SERVICE BULLETIN No. 007LG-32-14

LANDING GEAR - EXTENSION AND RETRACTION - CONTROL AND INTERFACE

INTRODUCTION OF DIGITAL BOARD PART NUMBER: 007-LG-04-0080 - AMENDMENT F DUE TO OBSOLESCENCE

A. Family Tree Chart of Amendment Relationships

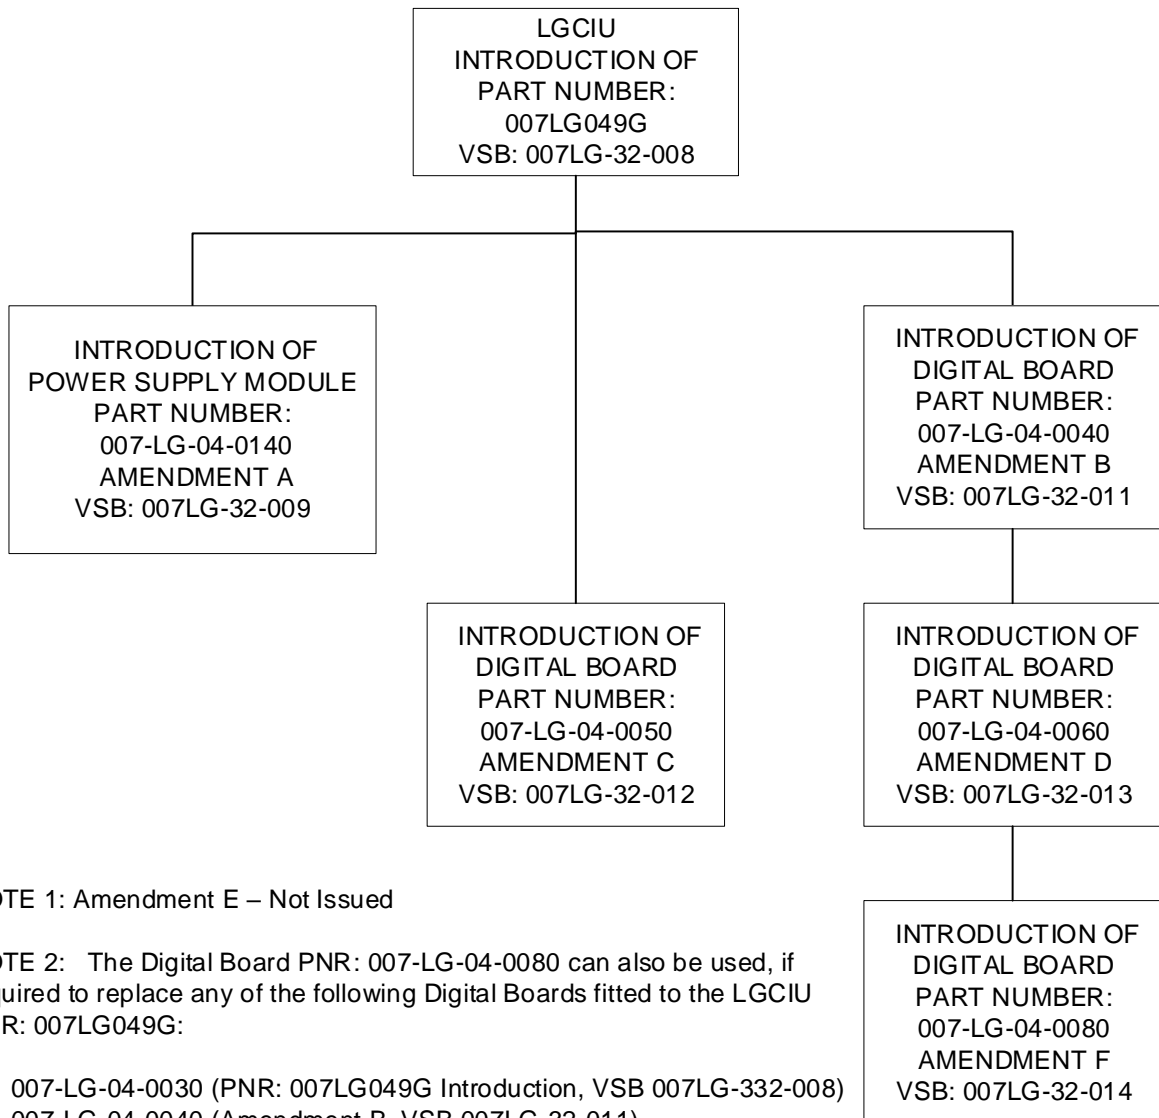
NOTE 1: Amendment E – Not Issued

NOTE 2: The Digital Board PNR: 007-LG-04-0080 can also be used, if required to replace any of the following Digital Boards fitted to the LGCIU PNR: 007LG049G:

- 007-LG-04-0030 (PNR: 007LG049G Introduction, VSB 007LG-332-008)
- 007-LG-04-0040 (Amendment B, VSB 007LG-32-011)
- 007-LG-04-0050 (Amendment C, VSB 007LG-32-012)
- 007-LG-04-0060 (Amendment D, VSB 007LG-32-013)
